Re: Response to Comments from First Reading on Mountain View SDD

Thank you for your consideration of the Mountain View SDD. I am writing to provide a response to comments from the Town Council at the hearing on December 5 and to provide an update to our proposal for your consideration.

south elevation

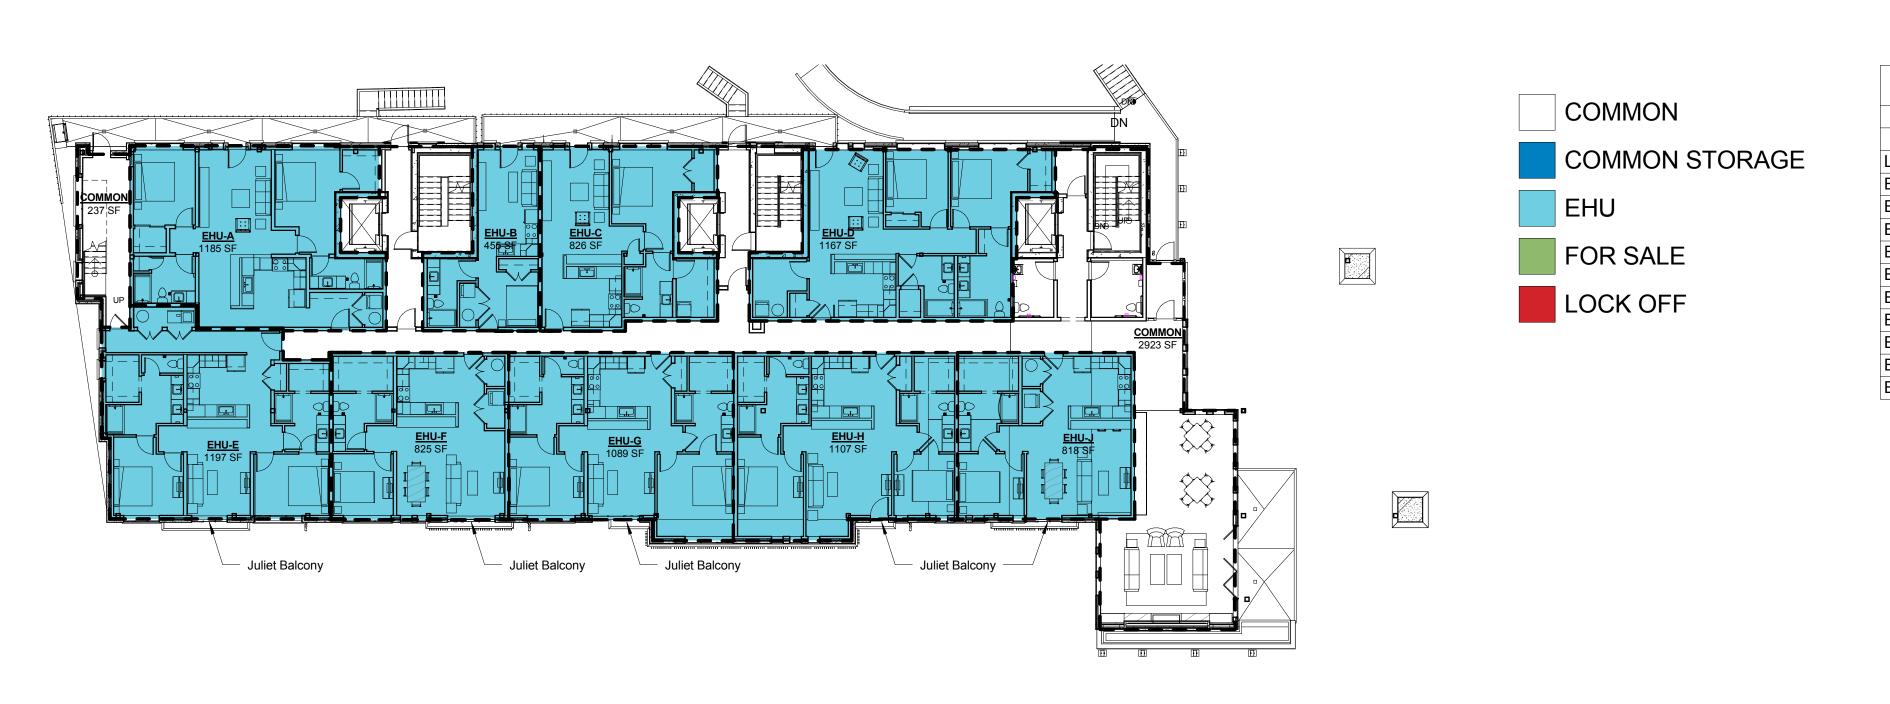
- Several of the Town Council members mentioned that the livability of the employee
 housing units could be improved with the addition of balconies on the south elevation
 so that occupants have some access to additional light and air. We have revised the floor
 plans and the south elevation of the building to provide juliet balconies on all of these
 EHUs. These balconies will allow the occupants to open the glass door to the balcony
 and experience additional light and air.
- In addition, the lobby area proposed on the second floor of the building will be a space that can be used by the occupants to meet and socialize within the building. The lobby includes a large outdoor deck area where residents can be outside, sit, and socialize. This lobby area and related deck space is an additional amenity that the residents have to enjoy on-site.

Attached please find the revised south elevation and the revised floor plans for Level 1 and 2 of the building showing the proposed balconies.
